Device **XC886LM-6FF**
Marking/Step **ES AB**
Package **PG-TQFP-48**

This Errata Sheet describes the deviations from the current user documentation. The module oriented classification and numbering system uses an ascending sequence over several derivatives, including already solved deviations. So gaps inside this enumeration can occur.

Figure 1 Critical Cases for Power up/ Power down when $V_{residual} > 500mV$

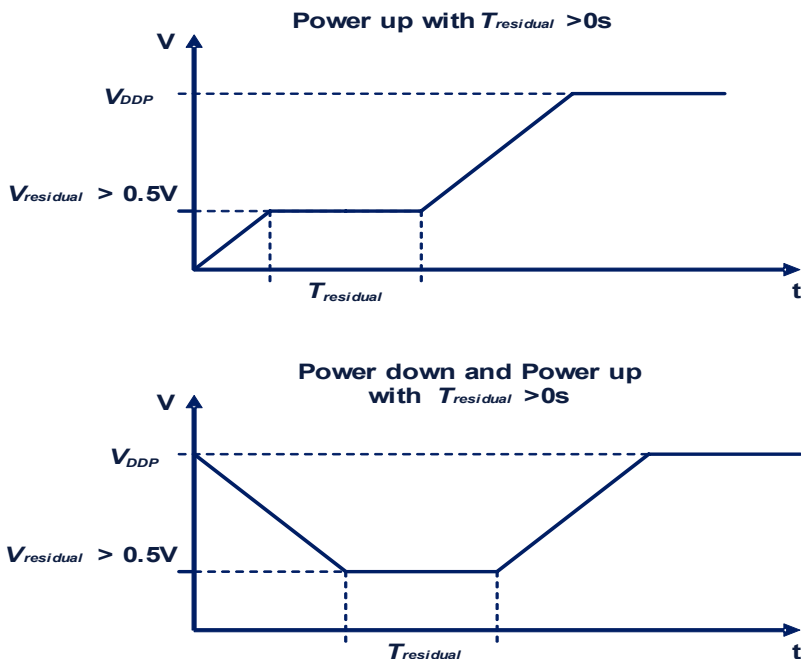
Due to the limitation of the EVR, the reset toggling may occur during the power up. To prevent the reset toggling issue for power up, the following conditions must be met :

1. For power up, the rising time must be less than $2\text{ms}/V$.
2. The power down time must be more than $0.2\text{ms}/V$.
3. A permanent V_{DDP} residual voltage is less than 500mV.

In case of V_{DDP} residual voltage is more than 500mV, the holding time of residual voltage affects the reset toggling issue. **Figure 1** shows the critical cases for power up/power down when the residual voltages is held for some time. **Figure 2** shows the uncritical case for power up and power down when the power up is triggered immediately after power down. In case of a residual voltage due to immediate power up after power down, the users have to contact IFX to ensure no power up failure.

Figure 3

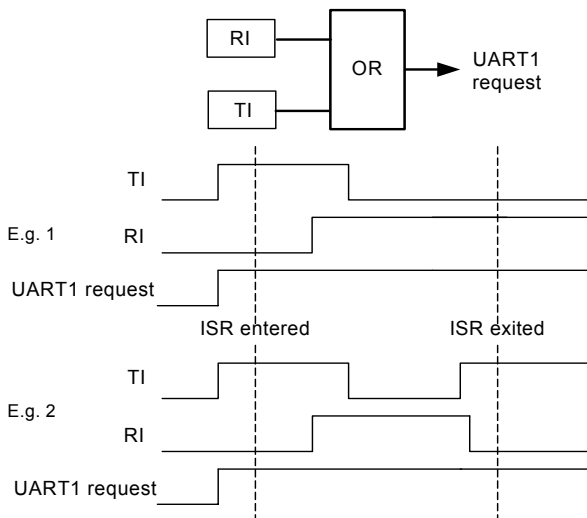
As illustrated in the simplified figure, the UART1 interrupt flags RI and TI are combined as one interrupt request output. These flags are located within the UART1 kernel, with a single interrupt request line as output from the kernel.

Being of interrupt structure 2, the interrupt request of UART1 is detected on the rising edge of a positive pulse.

The problem is that it may occur at some point in the application, that any new UART1 interrupt request can no longer be detected after a return-from-interrupt (reti) due to service of earlier event(s). This happens when the following conditions are true:

1. UART1 events are serviced by interrupt (i.e. flags are checked and cleared only in the interrupt routine ISR),
2. Either RI or TI is set at any one time throughout the ISR (even while the other is cleared) such that at least one of the flags is still set after reti, causing the UART1 request line, which is an OR-function of the two flags RI and TI, to remain set throughout the ISR and after reti.

1. If other events of interrupt node XINTR8 (EX2) need not be enabled for interrupt, disable this interrupt node and use software polling of the flags instead.
2. Before return from interrupt, check again if RI or TI is (still) set (due to new request since the last check). If so, jump and execute the ISR routine from start. Exit only when all flags are checked to be cleared. However, dummy

interrupt of the node may occur after return from interrupt, and should be ignored. Another drawback is if UART1 events are occurring at high rate, the CPU may be 'stuck' in the service routine of the UART1 interrupt for a long time.

Figure 7

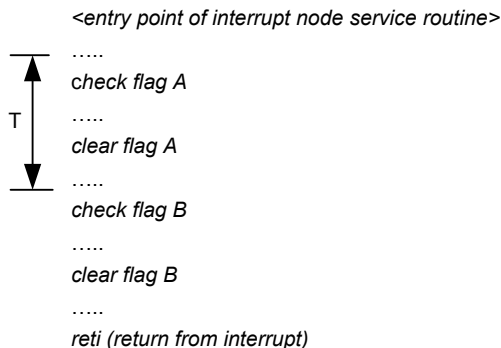
Consider the following NMI interrupt service routine pseudo-code, and scenario where a NMI interrupt source A event leads to interrupt request of the NMI node and CPU vectors to the NMI interrupt routine. Meanwhile, NMI interrupt source B and its flag becomes active any time in the duration indicated by T:

In this case, NMI flag B will be cleared as a standard procedure by the NMI interrupt routine in the current service. However, the pending interrupt request for the NMI node remains activated after RETI, as it is only cleared by hardware when CPU acknowledge the NMI interrupt and vectors to the NMI service routine.

This leads to following servicing of the NMI interrupt node again, but potentially no active NMI flag is found, i.e. dummy NMI interrupt service. The point to note is that the NMI interrupt source B is not lost, as it was actually serviced in the current service of the NMI interrupt node.

The recommendation is to ignore these dummy NMI interrupt vectoring.
